TEXAS UTILITIES GENERATING COMPANY

December 22, 1983
TXX-4089

COMANCHE PEAK STEAM ELECTRIC STATION
SUBMITTAL OF FSAR AMENDMENT
QA FILE: AMENDMENT 44
FILE: 10010

COMANCHE PEAK S.E.S. FINAL SAFETY ANALYSIS REPORT UNITS 1 and 2
PROJECT Q.A. ORGANIZATION
FIGURE 17.1-2

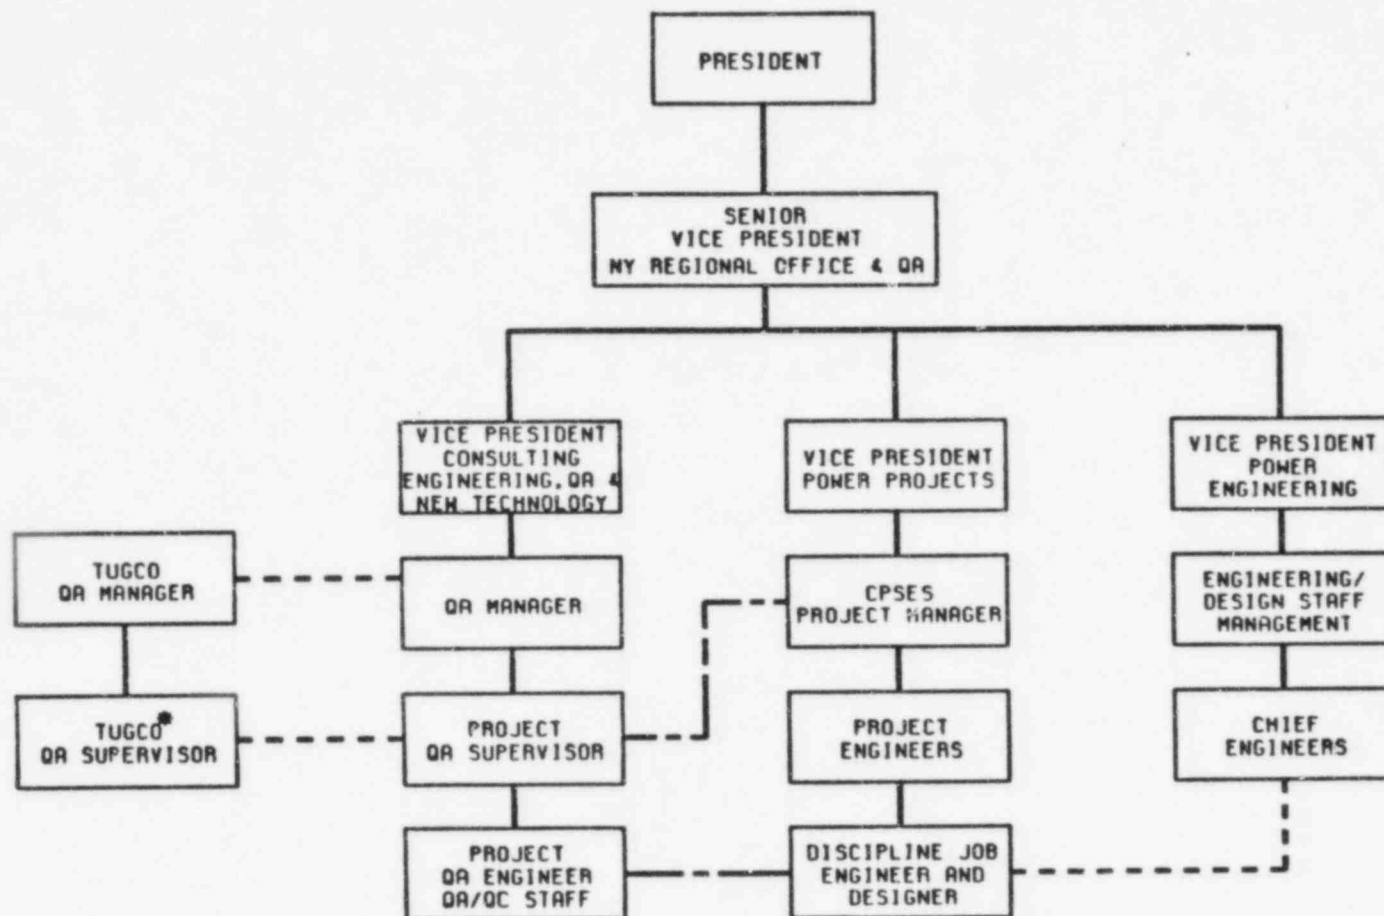
The revised program continues to satisfy the criteria of 10CFR50, Appendix B and the description previously accepted by the NRC. Amendment 44 reflects organizational changes within TUGCo/TUSI and Gibbs and Hill. Amendment 44 does not reduce our commitments nor the effectiveness of our QA program.
